Re: 60 Pittwater Road, Manly – BCA Advice

This document provides a schedule of BCA Fire Safety information for the new works only outlining details to be included in documents for submission with the CC in response to a request for information by the Certifier. The proposal is additions / alterations to an existing 3 storey building containing 2 dwellings.

Figure 1 – Horizontal Projection (Spandrel)

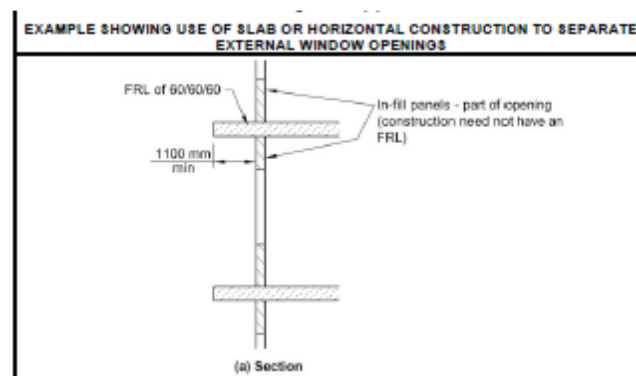
Openings in external walls of a building of Type A Construction must be separated from openings in the storey next below either by 900mm high vertical spandrel panels or 1100mm horizontal projections no less than 450mm beyond the relevant openings as shown in Figure 1 below.

Figure 2 – Vertical Spandrel

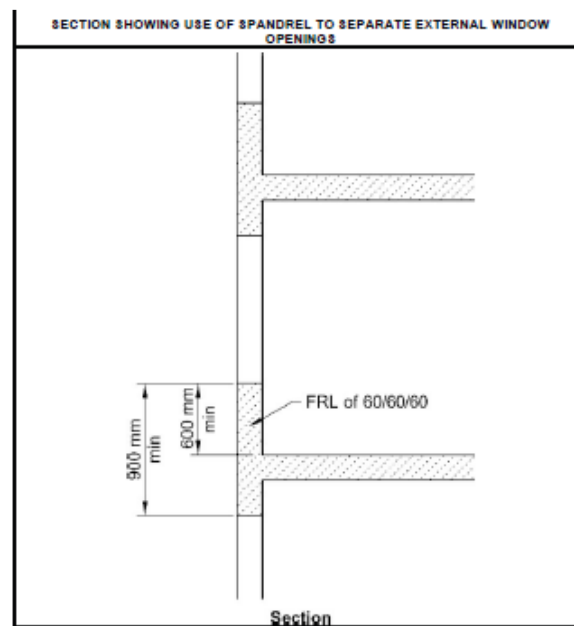
Vertical separation of openings in external walls at different storeys must be separated with fire rated spandrel construction having an FRL of 60/60/60 (both sides of wall) in accordance with BCA Clause C2.6. A 900mm high vertical spandrel must extend 600mm above the intervening floor as shown in Figure 2 below.

This predominantly applies to the following external walls containing windows at First Floor above proposed Ground Floor new windows with walls to be confirmed as having fire rated construction as detailed in Figure 2 as follows: -

- (i) Ground Floor proposed kitchen window W1 has a First Floor window above. The existing construction above W1 should be reviewed to confirm the wall achieves an FRL of 60/60/60 measured at least 600mm above the intervening floor with a total height of at least 900mm.
- (ii) Ground Floor proposed infill windows to street entry area has First Floor windows above. The existing construction above W1 should be reviewed to confirm the wall achieves an FRL of 60/60/60 measured at least 600mm above the intervening floor with a total height of at least 900mm.
